Fleet of the Future Design Update

June 12, 2014

- Share public feedback with Board
- Finalize design decisions regarding the proposed tripod poles and bicycle racks, to allow assembly of the cars to begin

Modifications To Address Concerns

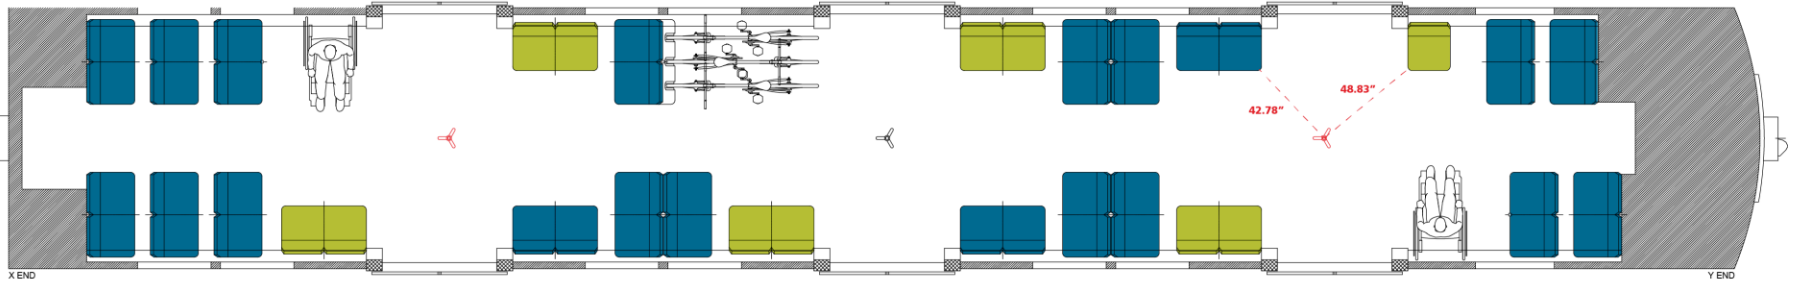
Discussions with BATF led to four steps to address concerns:

1. Pole offset by 4 inches. Creates four foot wide accessible path. Exceeds ADA standard and almost as wide as 54 inch door opening.
2. Wheelchair symbol embedded in floor
3. Pole marked with high contrast decal
4. Commitment to Clear The Path campaign

Alternative 1

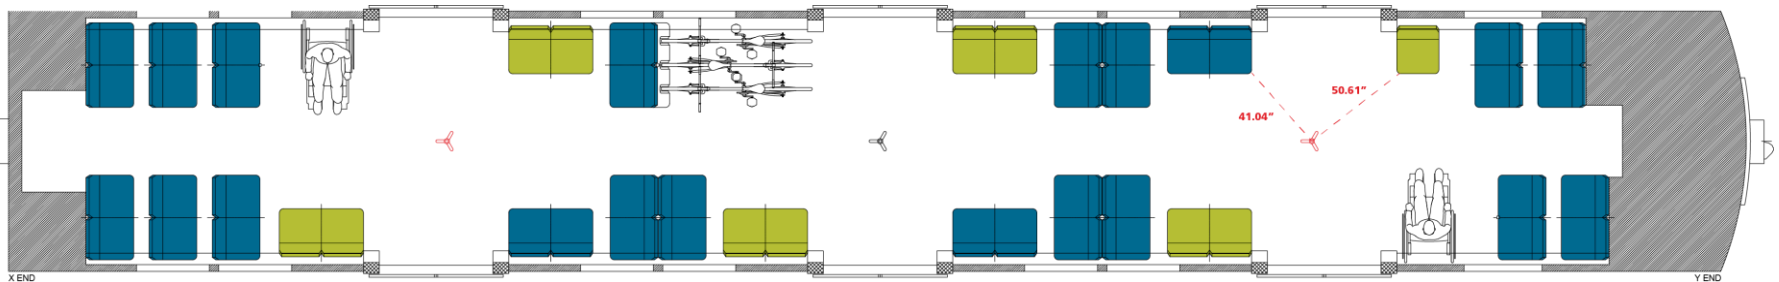
Increase End Door Pole Offsets to 6 Inches
(on all cars)

- On all cars, retain poles but increase offset of end poles to 6 inches.
- Upside: Makes accessible path to wheelchair area almost as wide as door opening (50.6 inches vs 54.0 inches).
- Downside: Decreases path to aisle to approximately 41.0 inches.
- Keeps 100% of poles for passenger use.

Alternative 2

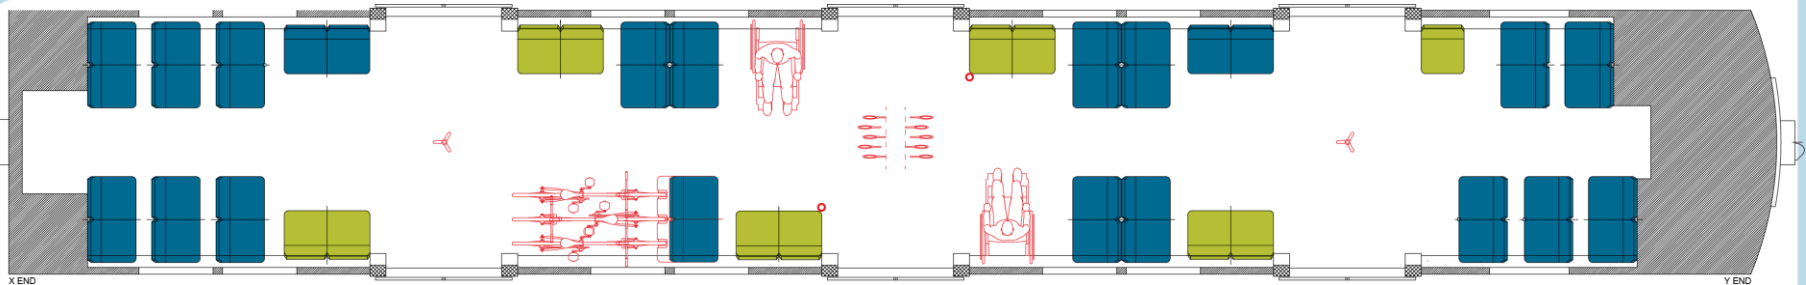
Wheelchairs and no pole at middle door.
(on all cars)

- On all cars, move wheelchair areas to middle door and bicycle rack to an end door. Replace middle door pole with ceiling straps.
- Upside: All cars have similar floor plan. A wheelchair user will find a wheelchair area immediately to the right as they board from either the center or outside platform. People who use wheelchairs can sit closer together. Less likelihood of boarding car and finding wheelchair space taken by another wheelchair user. This option works best after old fleet is retired.

- Downside: Only one door per car has wheelchair areas. Could be confusing during mixed fleet period: wheelchair users and bicyclists will be forced to reposition on platform upon train arrival – this has potential to increase dwell time and delays, and could force wheelchair users to be last to board. Straps are less stable handhold; tall customers may hit head on straps.

- Keeps 67% of poles for passenger use

Alternative 3

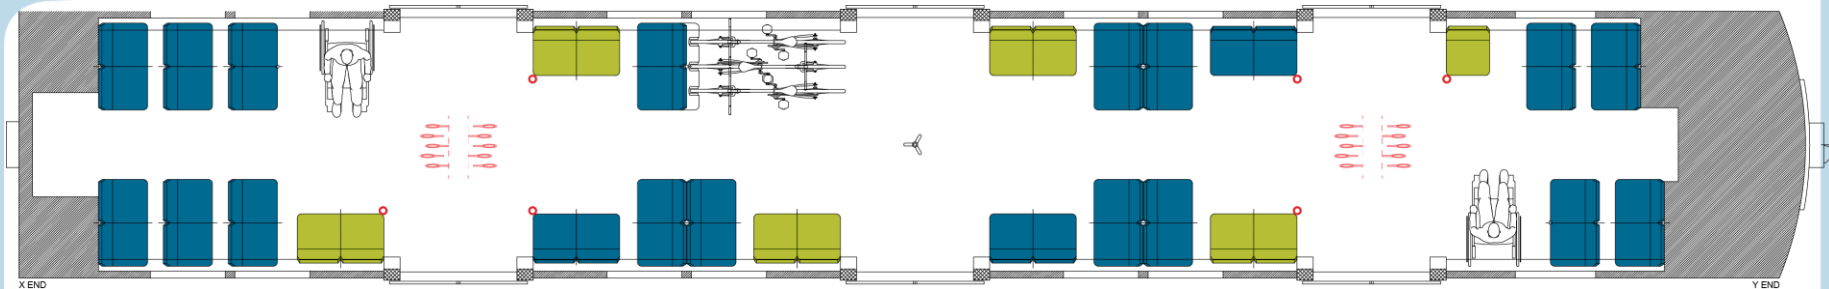
Remove two poles in cab car

- On cab cars, remove poles near both wheelchair areas and replace them with ceiling straps. On noncab cars, retain poles offset by 4 inches. Note: 40% of the BART fleet are cab cars, and there are always cab cars at both ends of a train at a minimum.
- Upside: Cab cars tend to be in a somewhat predictable position and will often be near platform elevators. End doors have similar configuration.
- Downside: Only one wheelchair space per door. Some wheelchair users will need to reposition on platform upon train arrival and cab car may not be close by. Straps are less stable handhold; tall customers may hit head on straps.
- Keeps 73% of poles for passenger use.

Pole Recommendation

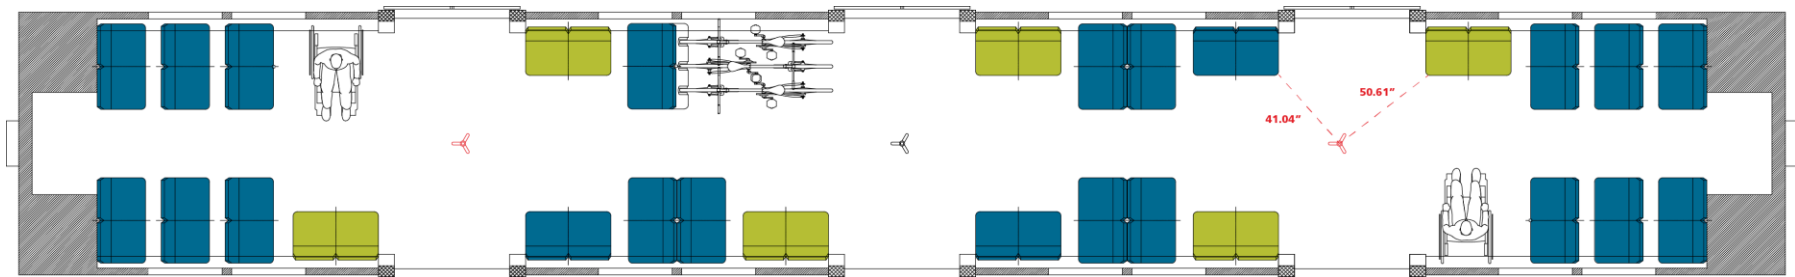
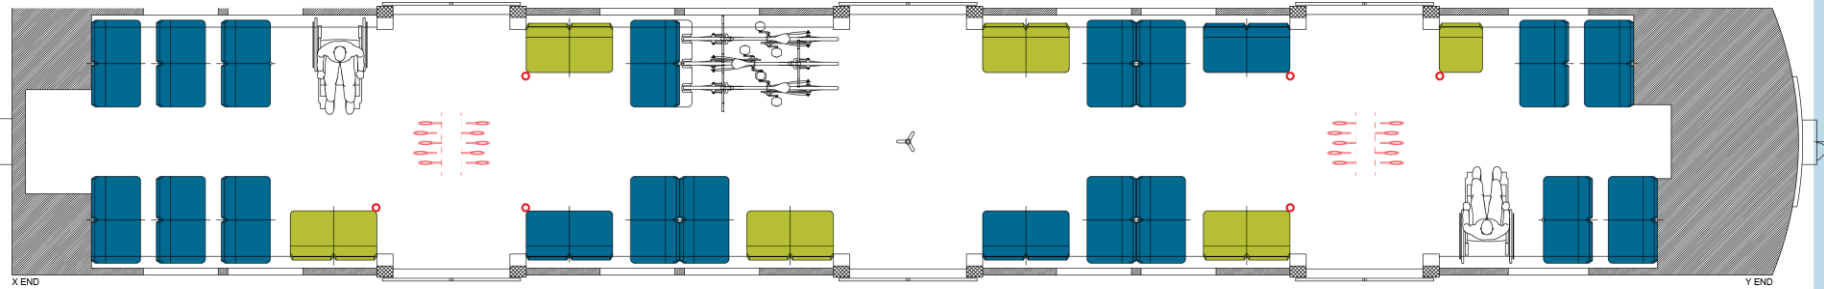
- Adopt hybrid of Alternatives 3 and 1 – Remove two poles on cab cars, and shift poles to 6 inch offset on non-cab cars.
- This recommendation:
 - Further offsets and removes poles to better serve people with disabilities, including those with large scooters
 - Keeps some poles for seniors, shorter people, and people with disabilities who need a stable handhold in the center of the doorway vestibule
 - Keeps wheelchair areas at end door locations during the mixed fleet period – providing consistency for people with disabilities.
